21. AIR

21.2 Greenhouse Gas Emissions

Figure 21-1 - Operational Emissions of GHG for TCD vs Desalination (Marsden Jacob, 2008)

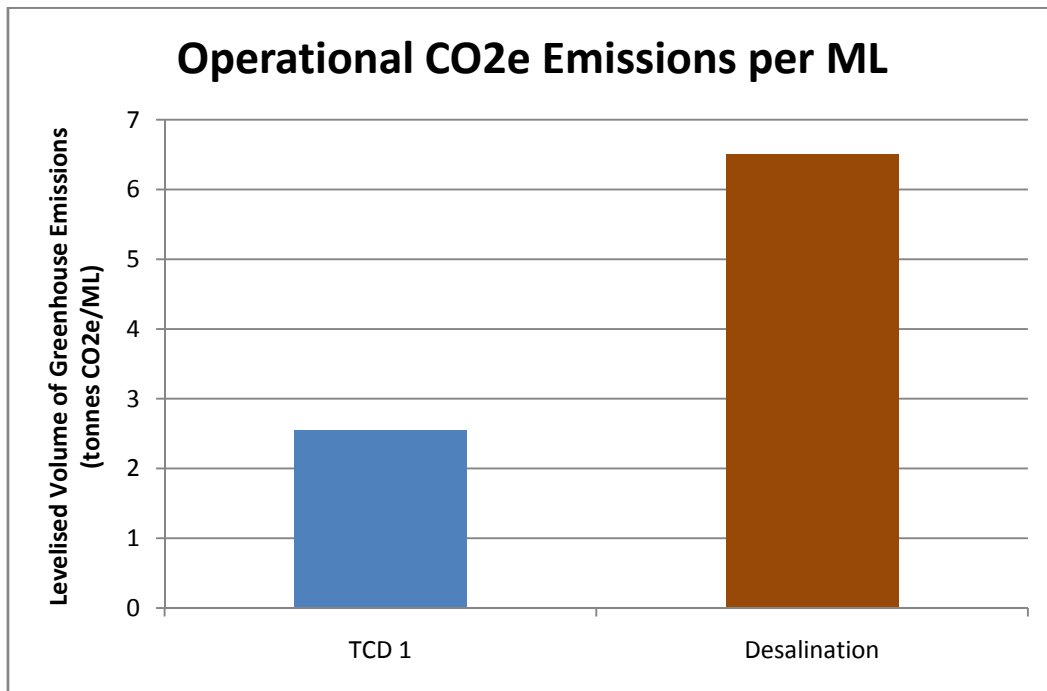
Issues were raised in submissions claiming that the EIS did not assess the proposal against other alternatives and their relative energy consumptions, and thus GHG emissions. Alternative strategies were assessed in the *Review of Water Supply Demand Options for South-East Queensland, February 2007* (Turner et al., 2007) and *South East Queensland Regional Water Supply Strategy – Energy Consumption Discussion Paper* (Kellogg Brown & Root, 2008). These alternatives included demand management options, desalination plants, indirect potable reuse, surface water and other dam locations. This information was presented as costs and net greenhouse gas emissions and has been used to inform the project. The EIS has considered this study in the comparison of alternatives in Chapter 2, section 2.4. Power demand and energy intensity comparisons have been made in some of the cases which have been considered in the overall justifications of the project.

An analysis of the comparative GHG emissions produced by the Project in comparison to a desalination plant located on the coastal areas north of Brisbane was conducted by Marsden Jacob (2008). This analysis concluded that a desalination plant would produce significantly more greenhouse emissions over the life of the Project. Consistent with the economic analyses

For the Project, the majority of the emissions are attributable to pumping water to and from the Water Treatment Plant (0.33 tonnes of CO_{2-e}/ML), treatment (0.45 tonnes/ML) and transmission through the Grid (1.67 tonnes of CO_{2-e}/ML), with emissions associated with the dam operations accounting for less than 1% (0.02 tonnes of CO_{2-e}/ML). The dam operations emissions are associated with the drawdown/fill sequences of the dam.

For the desalination option, over 82% of the volume of emissions (5.34 tonnes of CO_{2-e}/ML) is associated with the production of desalinated water, with the remainder (1.15 tonnes of CO_{2-e}/ML) associated with the transmission of the water.

In summary, the volume of emissions from the desalination plant is estimated to be around 2.5 times higher than the emissions associated with water delivered from the Project.

Over the 50 year period of the analysis, total emissions from the desalination plant (43.3 million tonnes) are estimated to be around 26.7 million tonnes of CO_{2e} higher than those from Traveston Crossing Dam (16.6 million tonnes) for an equivalent volume of water delivered into the SEQ Water Grid at a similar location.

Figure 21-2 Energy Required for Plant Operation / Water Treatment and Distribution of Various Water Supply Options

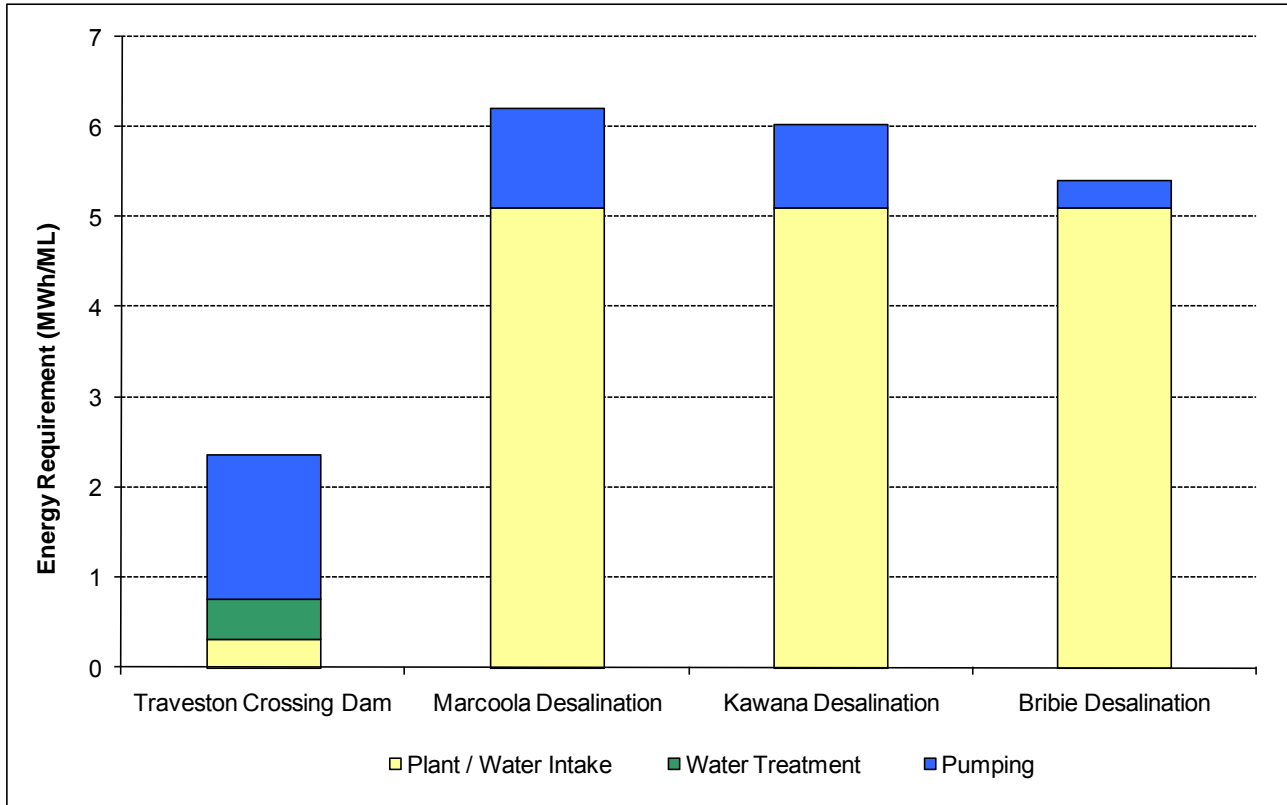
Submissions have also asked for information regarding operational energy consumption of the Dam and the Northern Pipeline Interconnector compared to alternative water supplies. The quantities presented here are considered the most up to date at the time of writing with regards to this project.

As identified in Chapter 2 of the EIS, an assessment of alternatives identified Traveston Crossing Dam as the most economically viable source of the necessary supply of water, with desalination as the next viable alternative. **Figure 21-2** provides a graphical representation of energy requirements for the production (i.e. plant energy or treatment) and distribution (i.e. pumping) of the Project compared to other potential desalination options. Here it can be seen that while the Project requires greater energy for water distribution, the total energy requirements are much lower for Traveston Crossing Dam than any of the desalination plant options.

Irrespective of the location of a desalination plant (including Marcoola, Kawana, or Bribie Island), which yields the equivalent amount of water as the Traveston Crossing Dam, the energy consumed by the desalination plant, and hence the GHG emissions, would be in the order of 2 to 2.5 times greater.

Figure 21-3 Annual Energy Acquisition Costs for a Desalination Plant or Traveston Crossing Dam (real 2008 dollars) via Commercial or Green Energy, each with Three Carbon Cost Scenarios (Energy Edge, 2008)

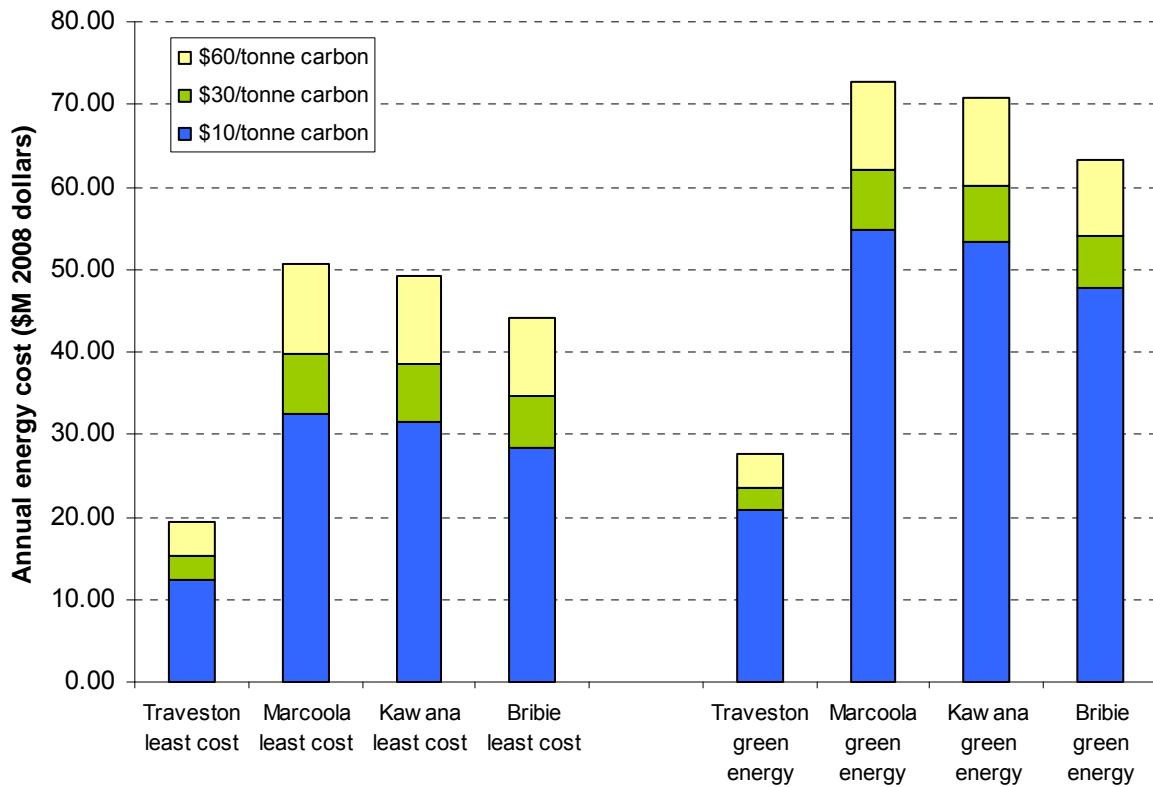
Submissions have queried whether renewable energy could be used to negate the impact of the significant greenhouse emissions that would be associated with a desalination plant located on the coastal areas north of Brisbane. It is recognised that renewable energy could be used to power a desalination plant, in the same way that renewable energy could be used to power the energy requirements of the Traveston Crossing Dam. However, it should be noted that the use of renewable energy has a significant cost burden associated with it. An analysis of the cost associated with the use of renewable energy was conducted by consultants Energy Edge (2008) (Appendix C19). This analysis concluded that the use of renewable energy for a desalination plant would increase the annual operating costs by \$22.1 million. In comparison, the use of renewable energy for Traveston Crossing Dam would increase annual operating costs by \$8 million. The reason that the use of renewable energy has such a significant impact on the annual operating costs for a desalination plant in comparison to the Traveston Crossing Dam is that desalination uses significantly more power. The results of the analysis are graphically in **Figure 21-3**.

The operating costs for each of the relevant scenarios above was then included in the overall whole of life costs for desalination and Traveston Crossing Dam. This direct comparison, as opposed to a comparison of water supply portfolios was undertaken as a sensitivity test in Marsden Jacob's 2007 Economic Report (s4.5.4 of the 2007 Economic Report).

Green energy costs further increase the differential in cost between the Project and desalination, with the cost of desalination being an estimated \$579 million to \$807 million greater than Traveston Crossing Dam if green energy is utilised (in favour of Traveston). These results show that the use of green energy adds an increased margin to the significant cost difference between Traveston
